APPENDIX 3 – Oxfordshire County Council Single Response (response and appendices A-D)

COUNTY COUNCIL'S RESPONSE TO CONSULTATION ON THE FOLLOWING DEVELOPMENT PROPOSAL

Application no: 24/00539/F

Location: Land To The East Of Stratfield Brake And West Of Oxford Parkway Railway Station, Oxford Road, Kidlington

Figure 5.1 – Journey Time Routes

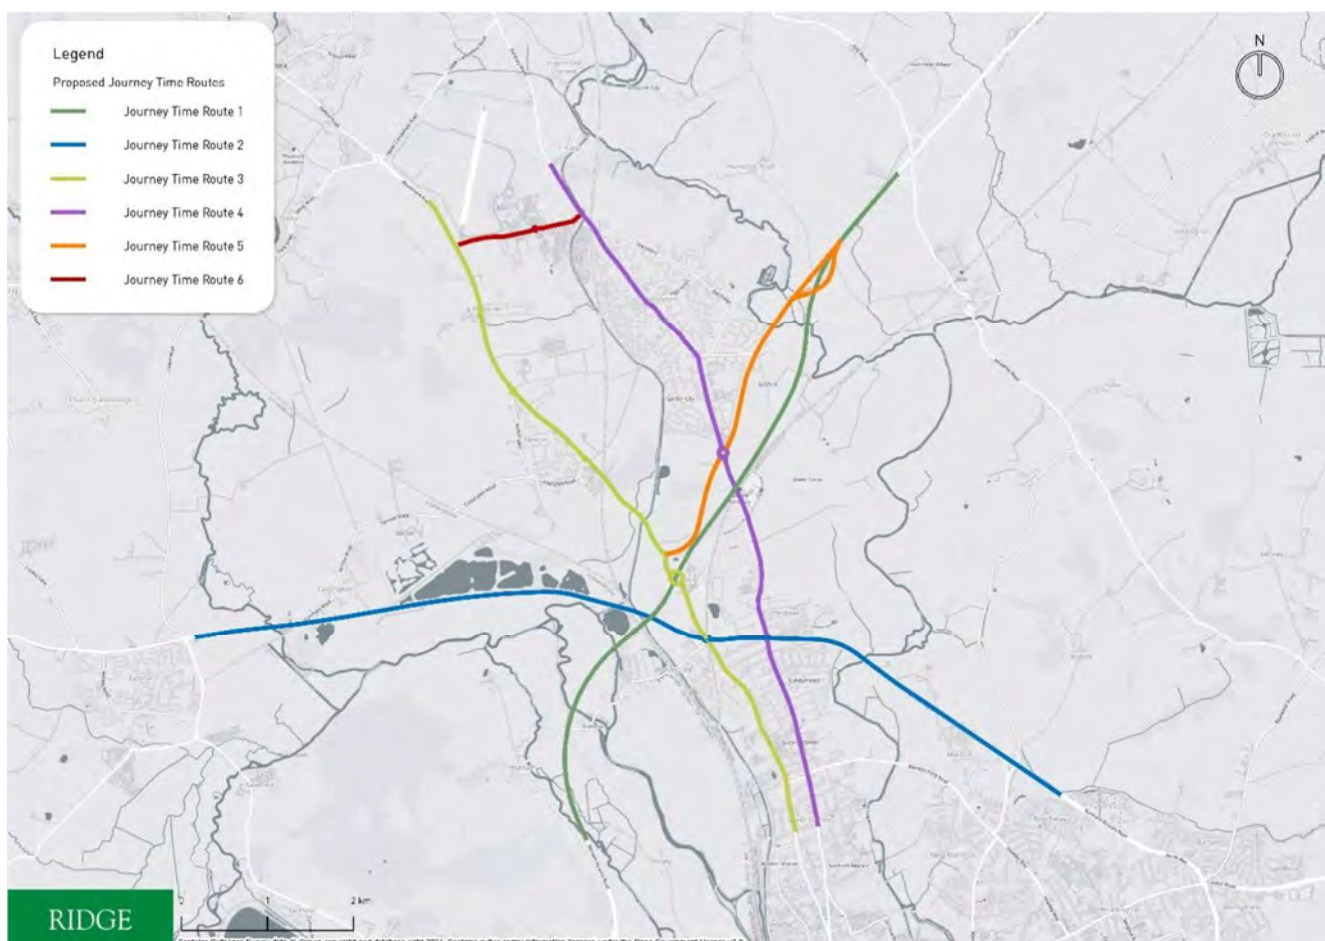
The journey time results were not included in the spreadsheet provided, therefore, the commentary is related purely to the tables provided in the Addendum report. The journey time routes are shown in Figure 5.1 below.

Table 4.6 of the AR shows that Route 3 NB is the worst affected between the kick-off times with nearly 2 minutes increase (8%) in the first hour. Routes 4 and 5 show small increase in all hours.
